DEPARTMENT OF ENVIRONMENTAL SERVICES

Division of Transportation

Subject: Macy's Ballston Site Plan #193 – TE&O Recommendations

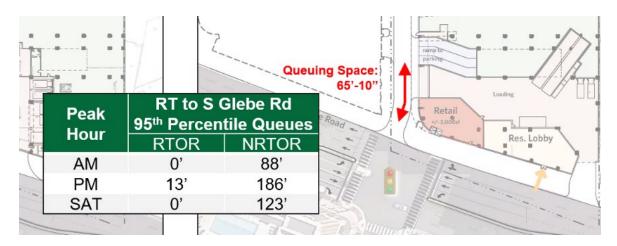
- Identify the safety implications and proposed mitigations of introducing a left-turn pocket at SB N Glebe Road/7th Street North. Below are areas of concern:
 - Existing pedestrian refuge of 9 feet to be affected
 - Proposed southbound left-turn lane is sufficient to accommodate 3-4 vehicles (75' storage pocket modeled per 2.11.22 MMTA Revision) and Future queueing results show the pocket queue to be 74' in both AM and PM peaks.
- Identify the safety implications and proposed mitigations of introducing an intense loading facility use adjacent to retail/residential parking garage in a constrained alley:

- There is no separation between the loading facilities and retail/residential garage entrance/exit
- Private alley known to have pedestrian traffic and is proposed to have four
 (4) driveways per recommended alternative as opposed to today's conditions of only two (2) driveways.

- Identify the operational impacts and proposed mitigations of introducing a left-turn pocket at N Glebe Road/7th Street North. Below are areas of concern:
 - The proposed left-turn pocket is seen to be at capacity per 2.11.22 MMTA Revision for both AM/PM peaks.
- Identify the operational impacts of signalizing the alley at N Glebe Road and introducing access points for both retail/residential uses and loading uses. Queueing space was shown to be insufficient based on developer's analysis; see below:

- Developer to list safety implications and proposed mitigations for areas of concern noted above
- Continue to explore other alternatives that do not degrade the safety or operations of roadways/intersections nearby
- Do not modify volumes to show post pandemic trends per scoping agreement.
